# 1988 - 1989 Corvette: Recall Notice: Rear Wheel Tie Rod

**Bulletin No:** 89C17

Subject: PRODUCT SAFETY CAMPAIGN 89C17  
REAR WHEEL TIE ROD

Model and Year: 1988-89 CHEVROLET CORVETTE

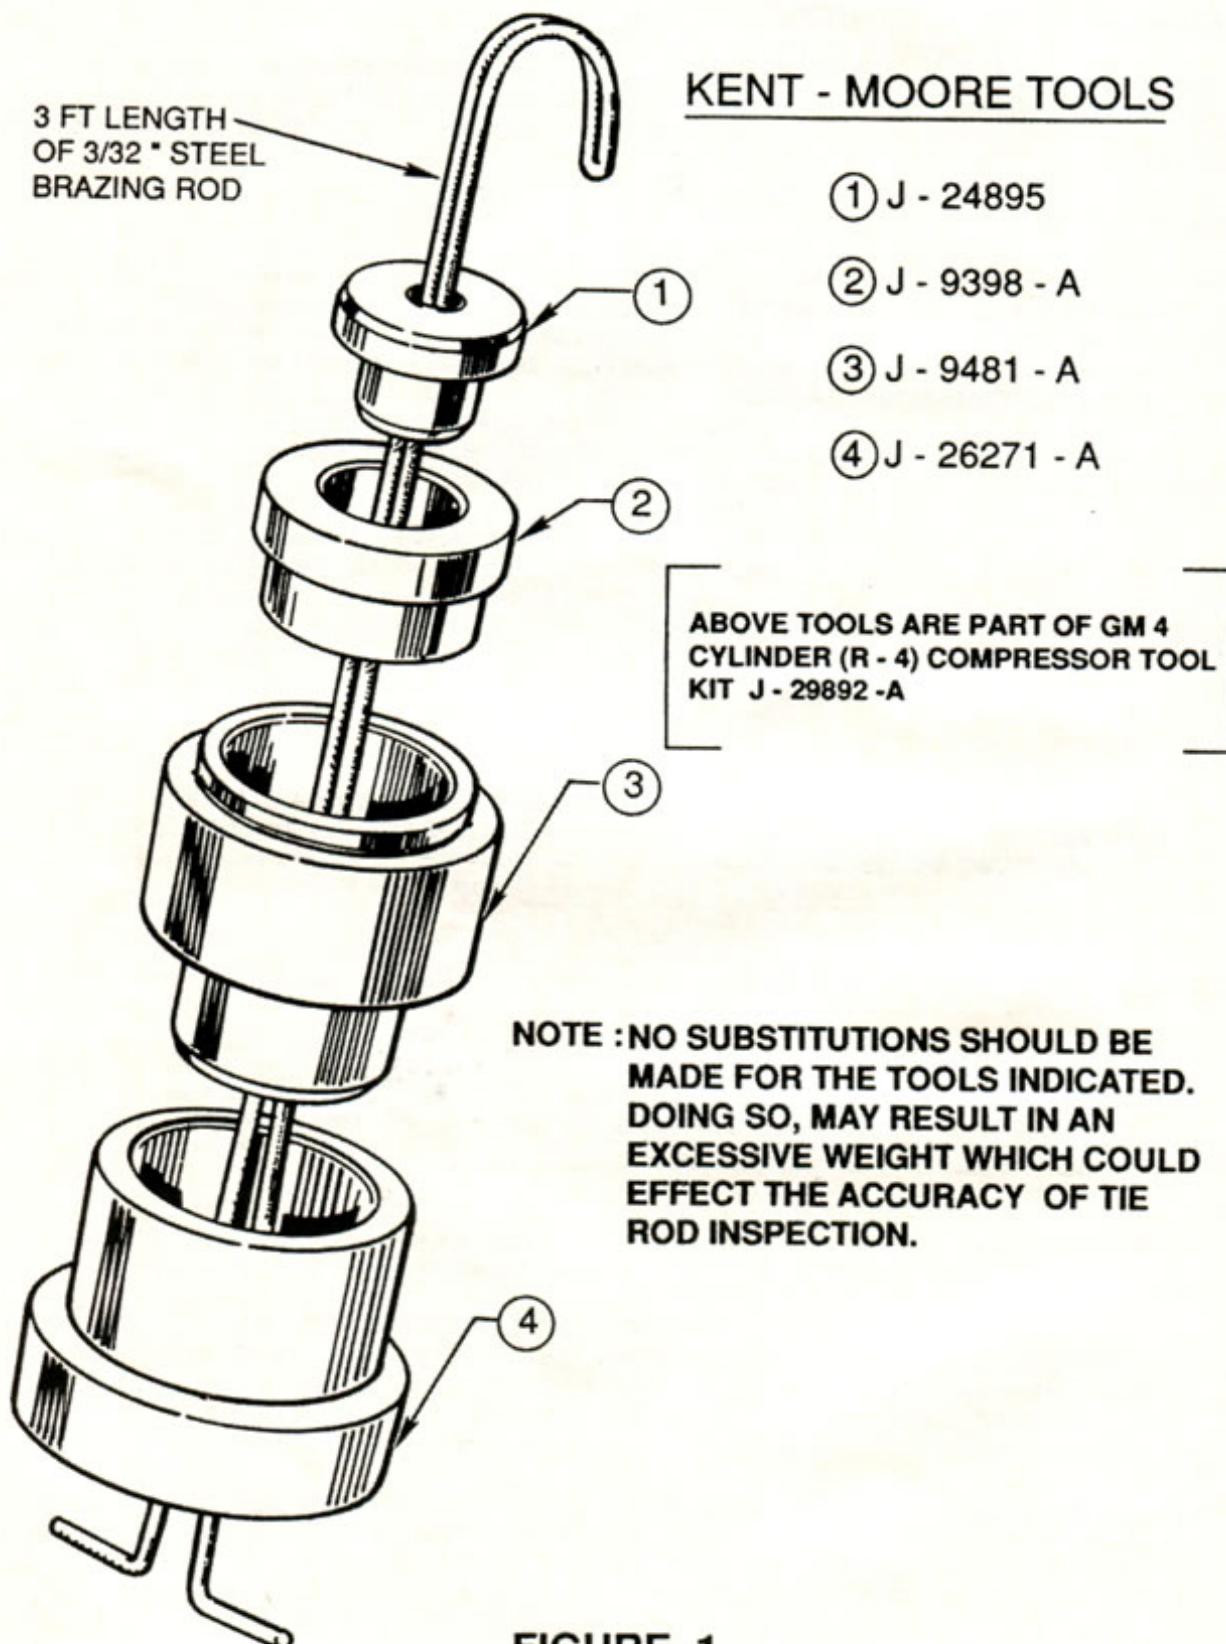
1. Fabricate/Assemble weight from materials indicated and as illustrated in Figure 1.
2. Raise Vehicle.
3. Remove cotter pins, nuts and washers from both outer rear tie rod ends and disconnect from knuckle assemblies utilizing tool J-24319-01.

FIGURE 2

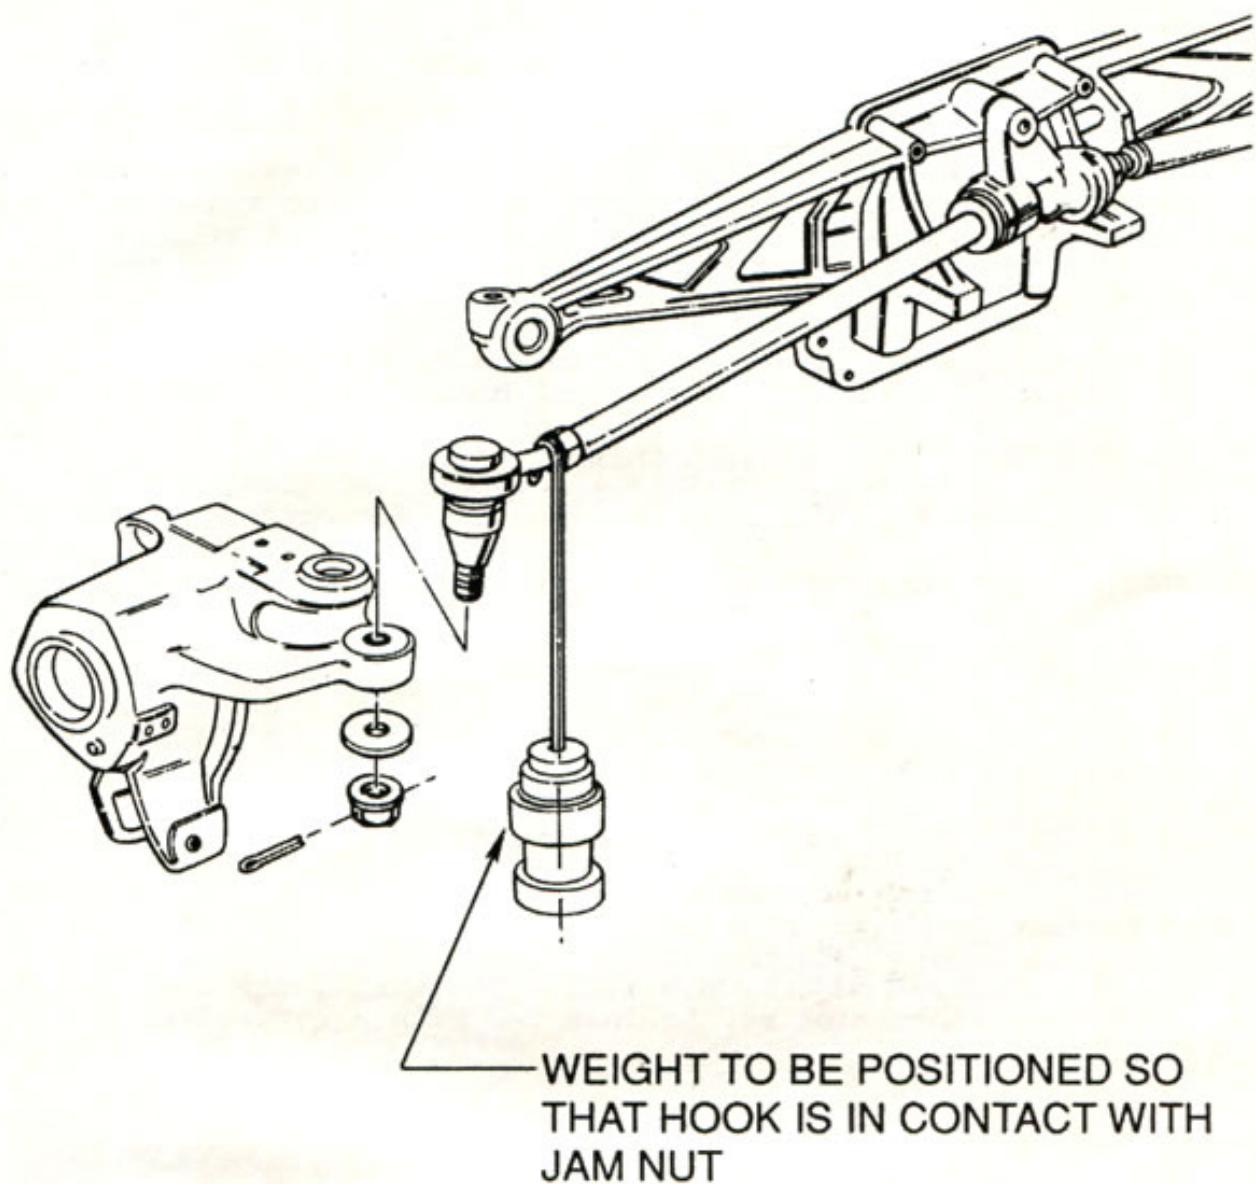
4. Raise and hold outer end of left hand tie rod linkage in its upper most position, insuring rod is not rotated while being raised. Attach weight as shown in Figure 2, release linkage and note results. Repeat procedure on right hand tie rod linkage.
5. Based on observations noted in performing step 4, select appropriate action from those noted below:
  - A. Linkage moves downward on both sides - Reconnect tie rod sockets to knuckles, install washers and nuts, torque nuts to 45 Nm (33 lbs. ft.) and install cotter pins.
  - B. Linkage on either or both sides doesn't move downward - Replace tie rod assembly, transferring existing tie rod ends to new assembly and following Section 3D in the Chevrolet Corvette Service Manual of the appropriate year.
6. Install Campaign Identification Label.
